From: Christine Catalano <Christine@accudock.com>
Sent: Friday, January 24, 2014 3:55 PM
To: Stauffer, Richard
Subject: AccuDock - ADA Kayak Launch/ ADA Gangway references
Attachments: Palm Beach ADA 1.JPG; Palm Beach ADA 4x32 ADA GW.JPG; Palm Beach ADA 3.JPG; Palm Beach ADA 2.JPG; AHA-048 Hinge Assembly 48in.pdf; ADA Kayak Launch Specifications Palm Beach Cty 2013 (2).pdf; PKG-TRF1.pdf; ADA-CompliantSystems.pdf
Importance: High

**12'x18' ADA TRANSFER PACKAGE #1
WITH 3'x8' SAFE LAUNCH**

Subject: City of Dallas - White Rock Lake Floating Dock

From: Christine Catalano <Christine@accudock.com>
Sent: Tuesday, February 04, 2014 4:09 PM
To: Stauffer, Richard
Subject: AccuDock - Materials Detail (ADA Kayak Launch/ ADA Gangway)
Attachments: AccuDock Materials Detail City of Dallas White Rock Lake ADA Kayak Launch.pdf; 0005-14 City of Dallas.pdf; ADA Kayak Launch Specifications City of Dallas.pdf

DRAWN BY:	C. OLIVER	02/03/14
CHECKED BY:	J. HARRISON	02/03/14
DRAWING NO:	0D0514	02/03/14
SCALE:	NOT TO SCALE	(954) 785-7557

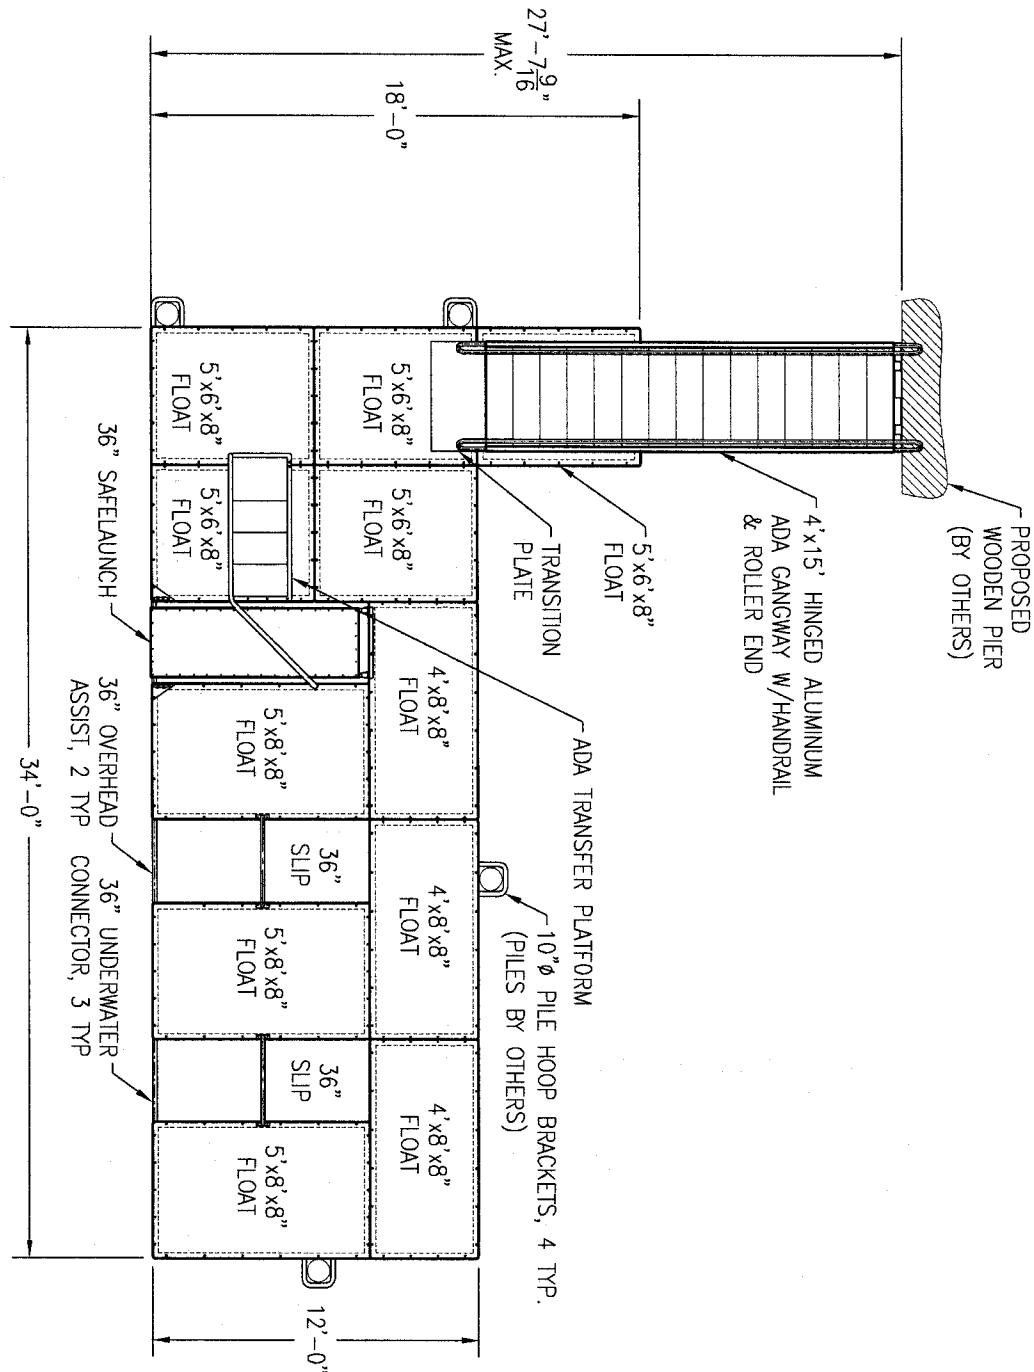
Really need to widen the gangway & remove the railing. If this cannot be accomplished then I need to install a wooden dock in the water & have a plate or something in-between the wood & floating docks.

SITE LAYOUT

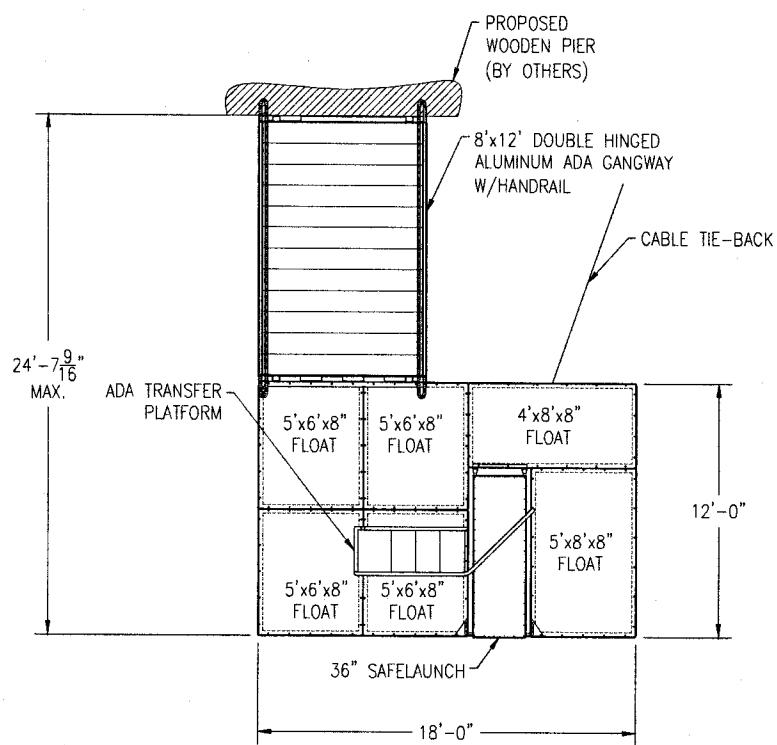
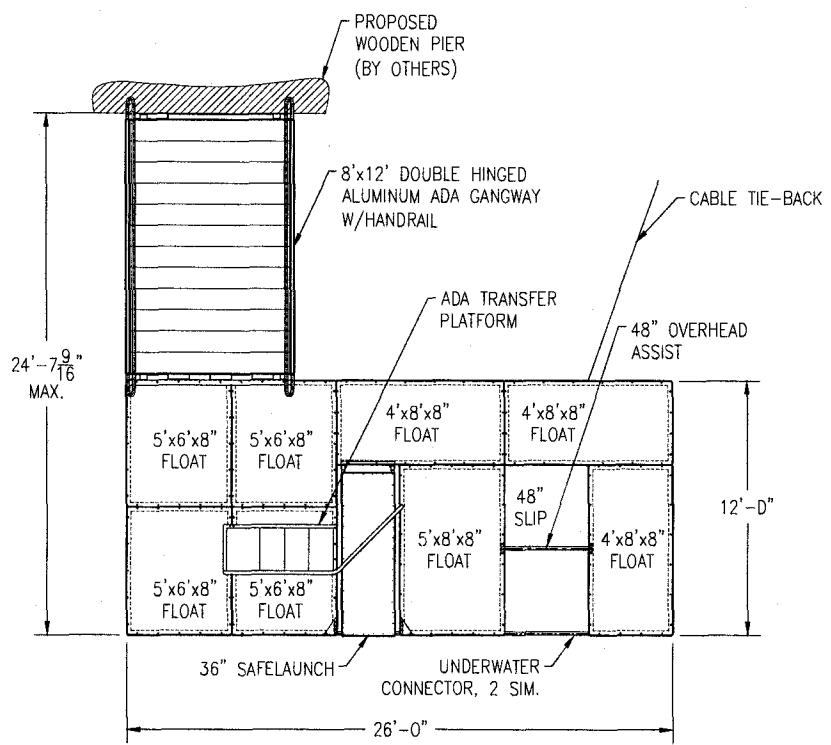
Please add the piers holding the docks in place. We get a lot of flow coming down the creek into the lake & would like to have additional support.

The ramp will need to roll on dock and not hinge if secured on pilings. This will take up much of that entry footprint of the dock. With the ramp rolling on the dock, would also need to add two additional floats – landward side to maintain the ADA clearance from ramp to the transfer platform.

I can revise design with both options for comparison.

SITE LAYOUT

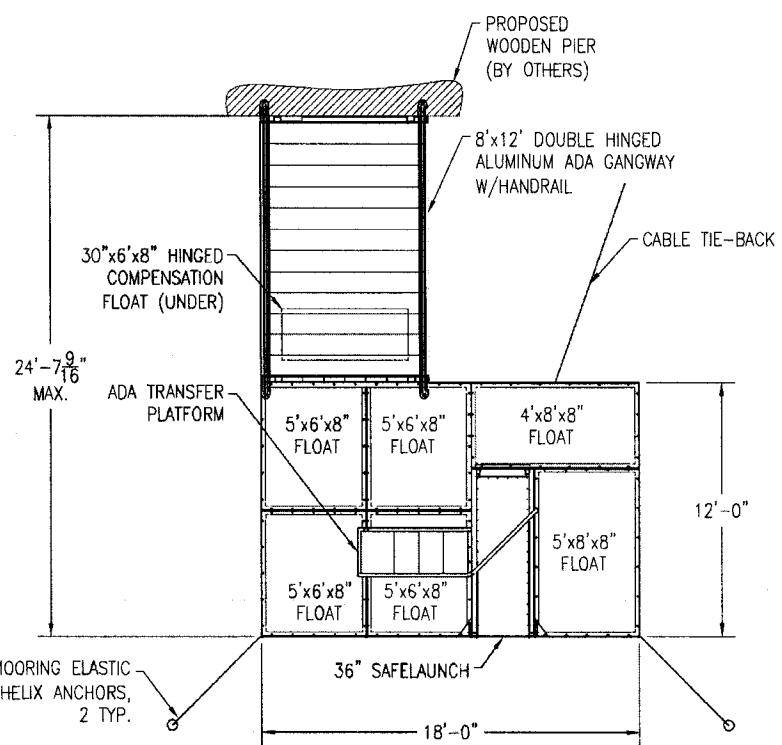
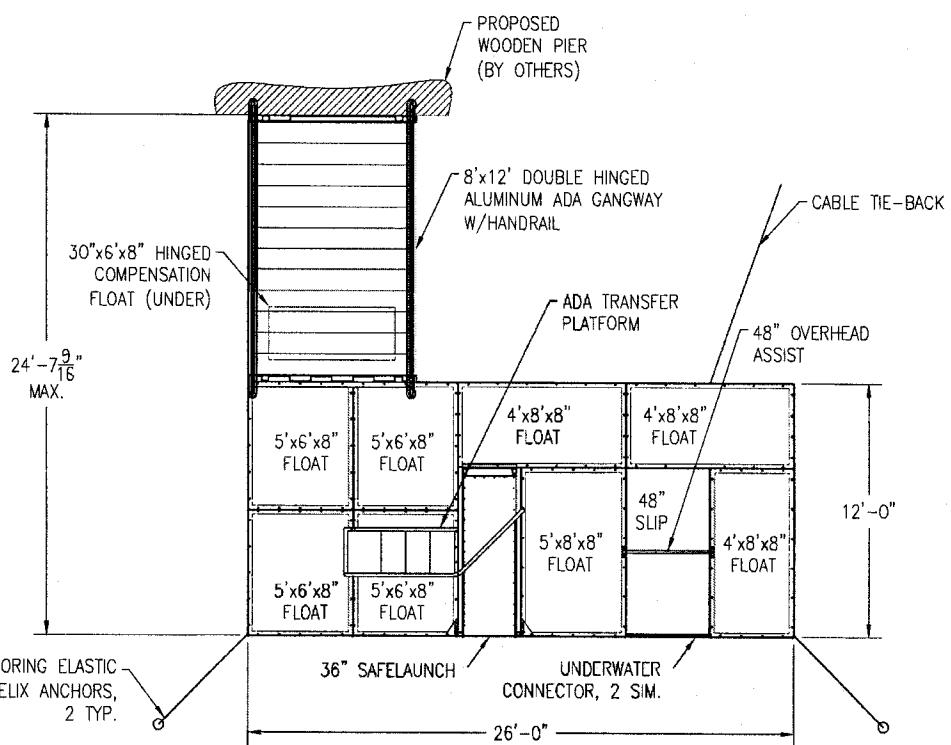
Please see attached revisions on the Base ADA Kayak Launch and Alternate double launch design. The compensation float is added as well as the Eco Mooring anchoring recommended.
